ADDENDUM

PROJECT: University of Nebraska - Kearney
West Center – Interior Upgrades, Phase I
Kearney, Nebraska

AD-1

DATE ISSUED: Wednesday, May 4, 2016

From Sheet:	E-101	for CA use:
Drawing #	E-1-1.2

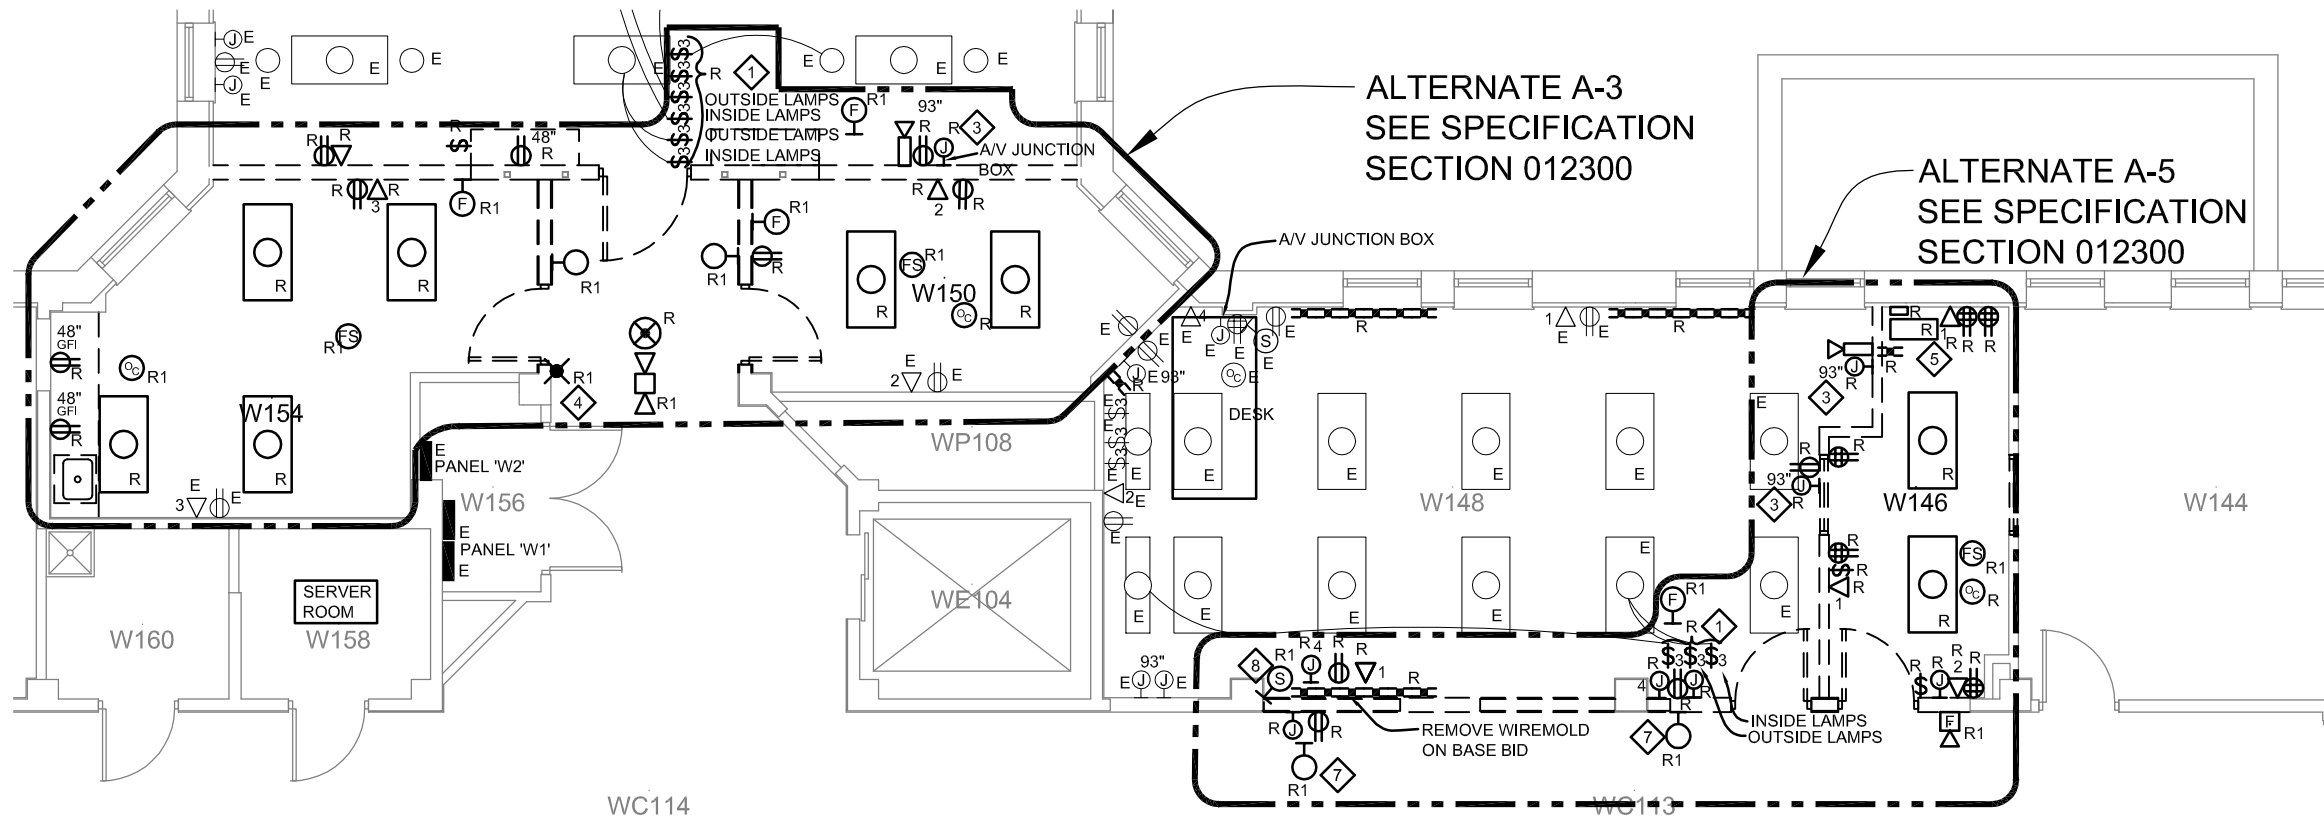
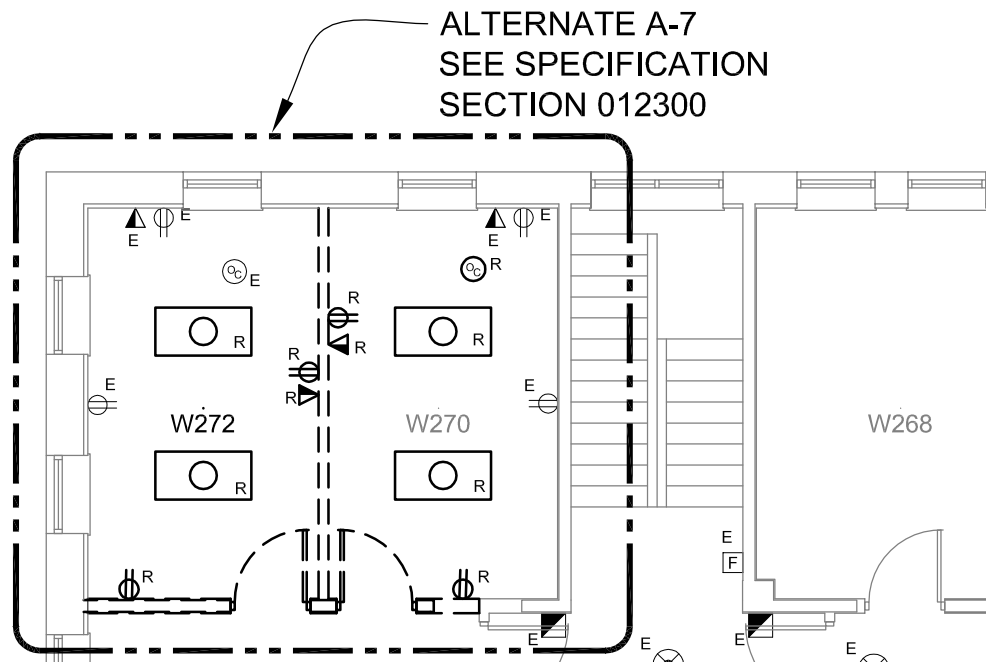
In reference to Sheet E-101, Plan 1 and 2, for alternate work clarifications, see attached Supplemental Drawings E101.1 and E101.2.

From Sheet:	E-102	for CA use:
Drawing #	E-102.1

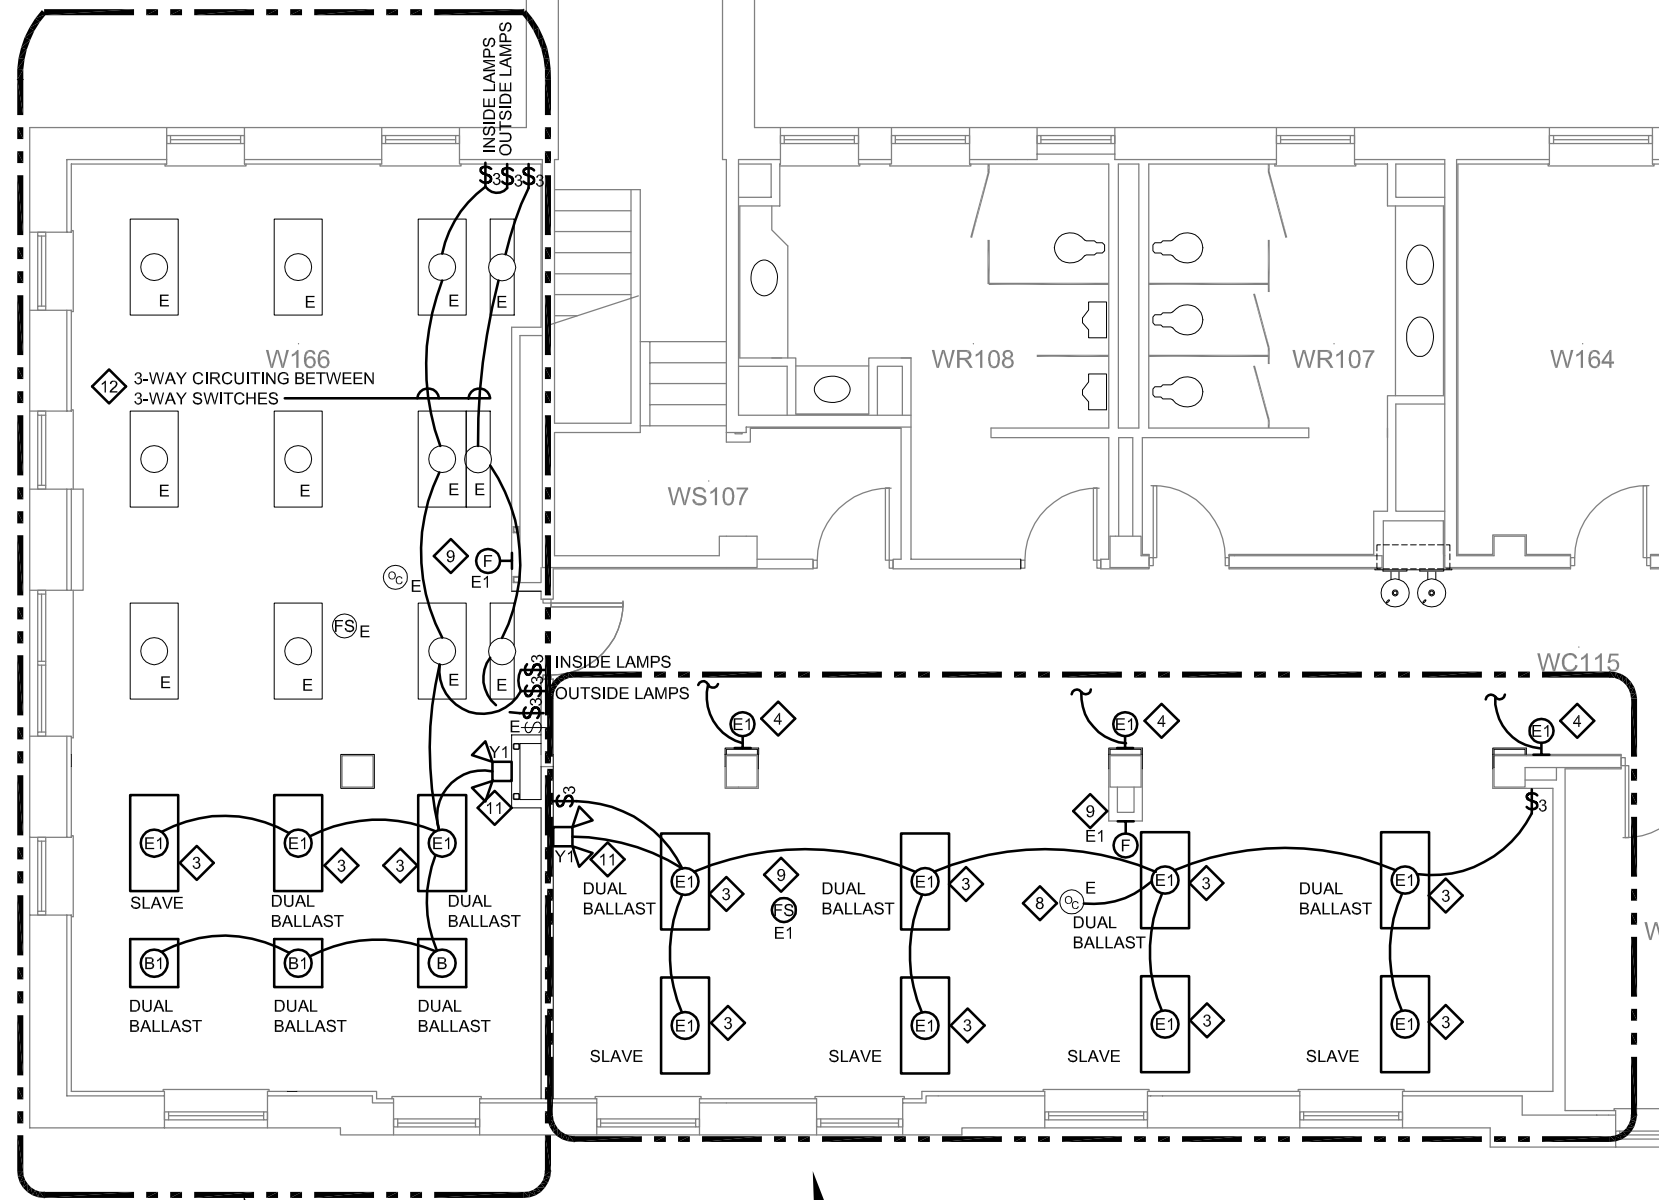
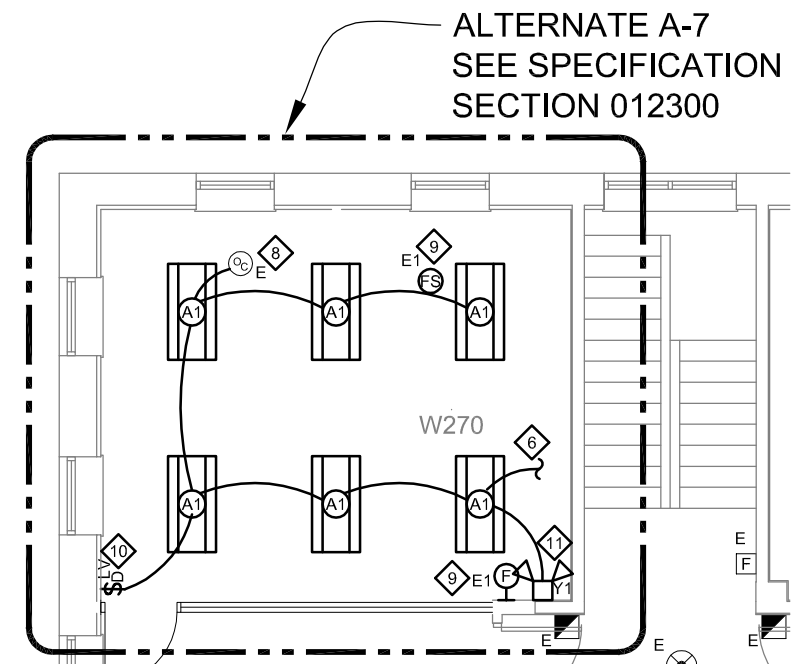
In reference to Sheet E-102, Plan 1 and 2, for alternate work clarifications, see attached Supplemental Drawings E102.1 and E102.2.

From Sheet:	E-103	for CA use:
Drawing #	E-103.1

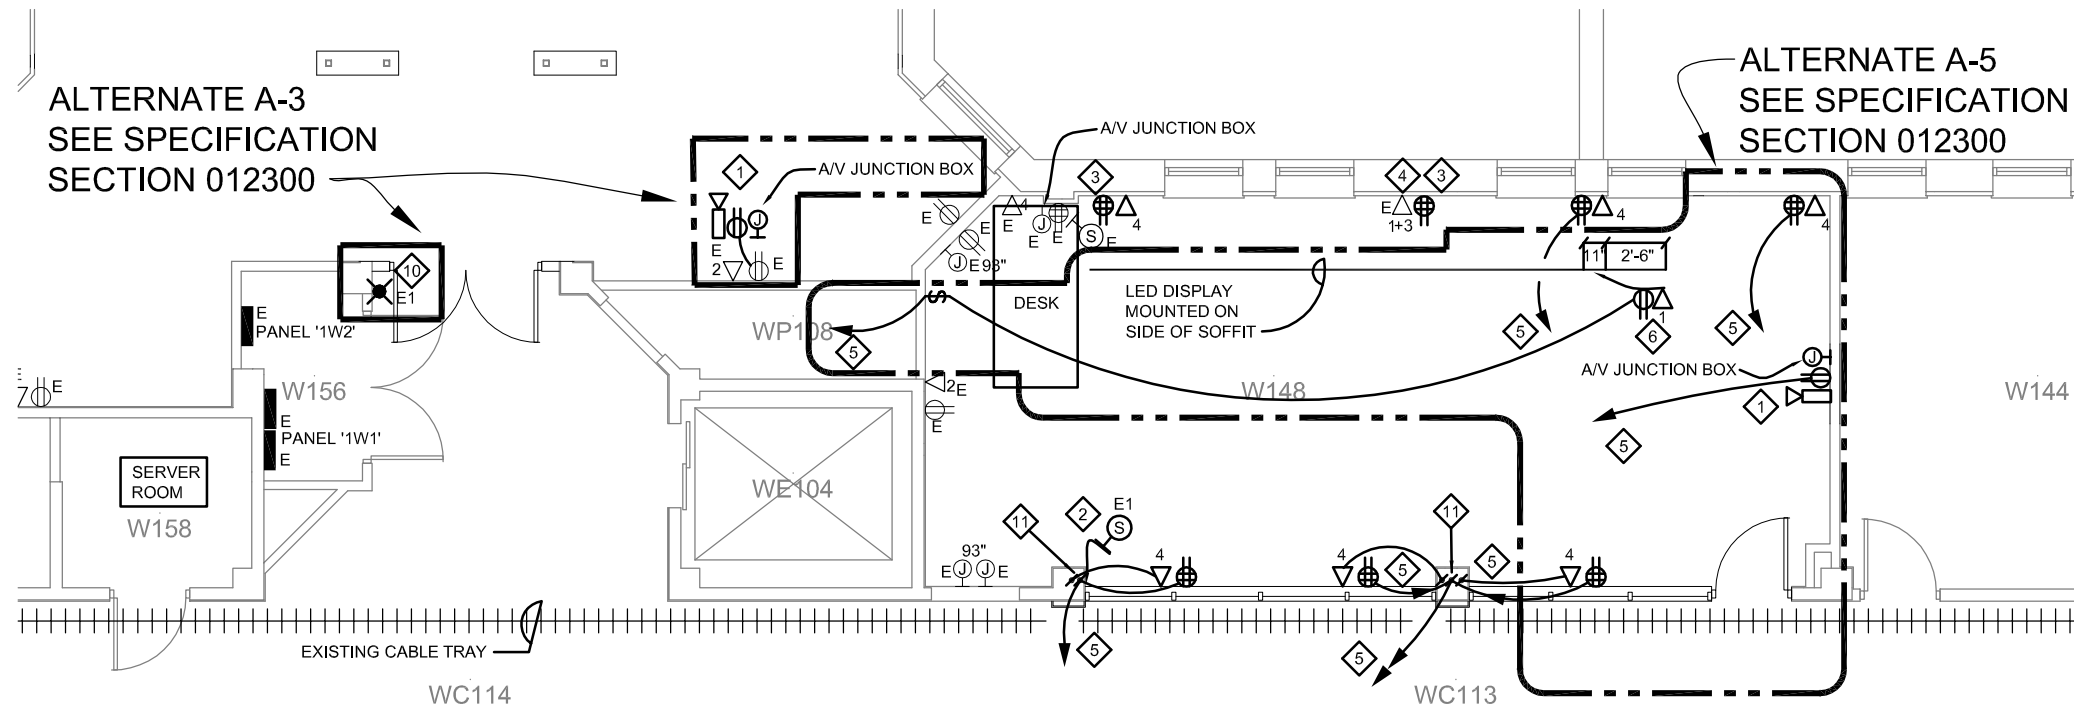
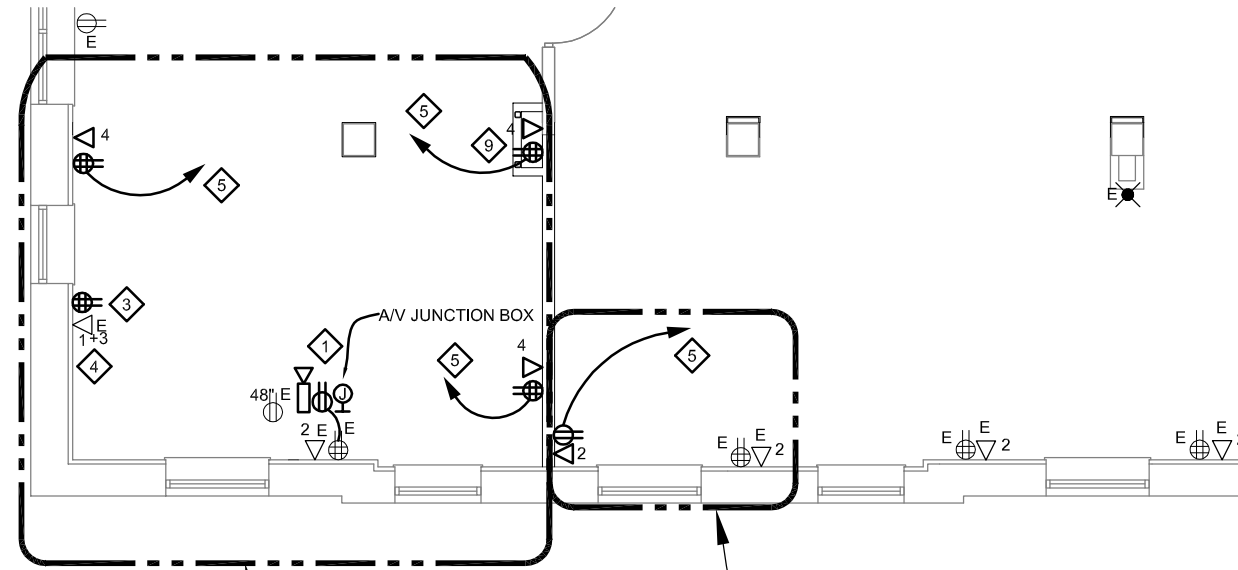
In reference to Sheet E-103, Plan 1 and 2, for alternate work clarifications, see attached Supplemental Drawing E103.1. Also see information for 5x5 telcom box.
